UNITED STATES PATENT AND TRADEMARK OFFICE

| APPLICATION NO. | FILING DATE | FIRST NAMED INVENTOR | ATTORNEY DOCKET NO. | CONFIRMATION NO. |
|---|-------------|----------------------|---------------------|------------------|
| 10/524,631 | 03/29/2007 | Shigemitsu Kikuchi | KUD-003 | 1444 |

Office Action Summary

DETAILED ACTION

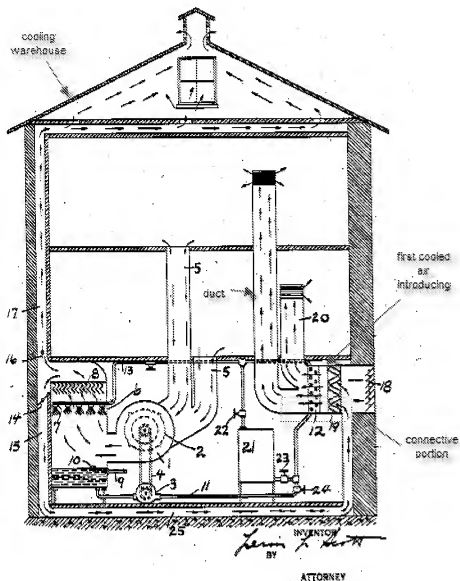
Claims 1 and 7 are rejected under 35 U.S.C. 102(b) as being anticipated by Scott US Patent No. 2,118,949.

Regarding claim 1, Scott teaches in fig. 1, a cooling warehouse (See annotated figure below) comprising, a first cooled air introducing pipe (See annotated figure below) introducing a first cooled air cooled by an air refrigerant type cooling apparatus 12, a second cooled air introducing pipe 25 taking in second cooled air in said cooling warehouse, wherein said second cooled air introducing pipe 25 is set inside of said cooling warehouse, a duct (See annotated figure) in the cooling warehouse, a connective portion (See annotated figure) inside the cooling warehouse connecting the

first cooled air introducing pipe to the duct in the cooling warehouse at a downstream side of the connective portion with the second cooled air introducing pipe 25, wherein the connective portion (see annotated figure) is capable of mixing said first cooled air and said second cooled air.

Regarding claim 7, Scott teaches the invention as disclosed above and further teaches in fig. 1, a cooled air feeding fan 1 disposed in the warehouse (see annotated figure) and capable of supplying the second cooled air to be mixed with the first cooled air at the connective portion (see annotated figure).
